**HISTORIC LANDMARK COMMISSION**  
**APPLICATION FOR A CERTIFICATE OF APPROPRIATENESS**  
**NOVEMBER 1, 2023**  
**HR-2023-131661; GF-2023-131679**  
**ROBERTSON/STUART & MAIR HISTORIC DISTRICT**  
**1107 EAST 10<sup>TH</sup> STREET**

Construct an accessory dwelling unit.

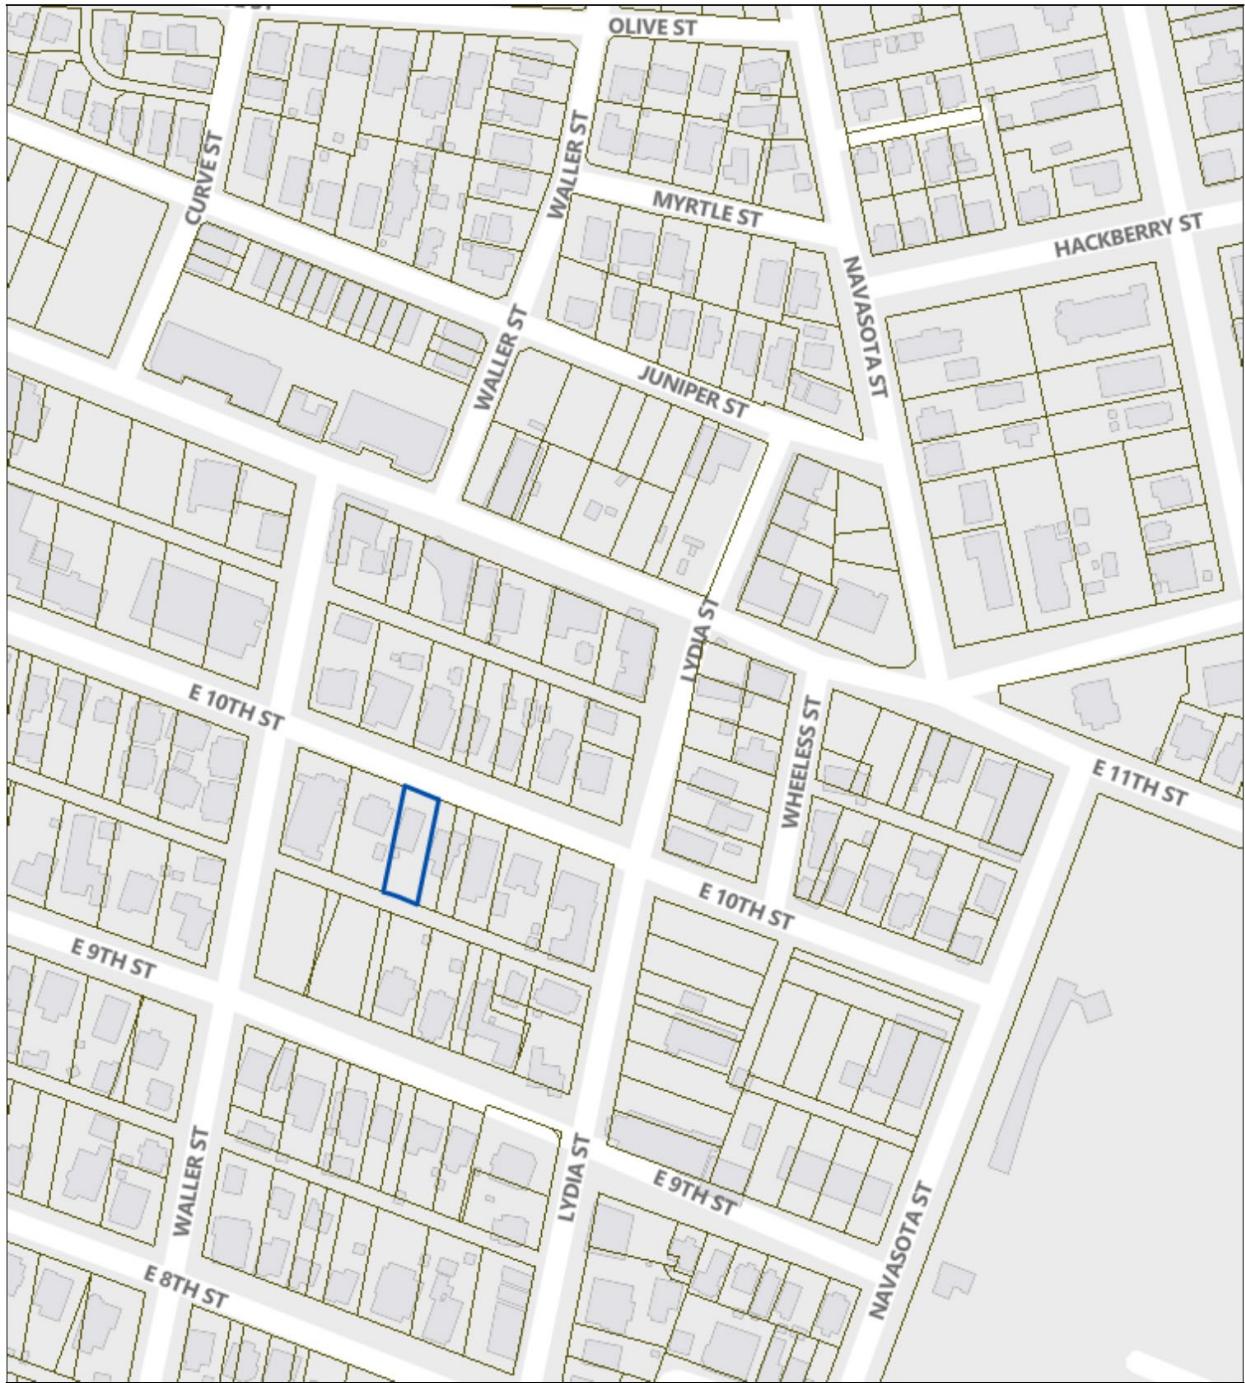
Use horizontality to reduce perceived height. Consider changing the fixed front-facing window to multiple rhythmic windows. Use siding rather than stucco.
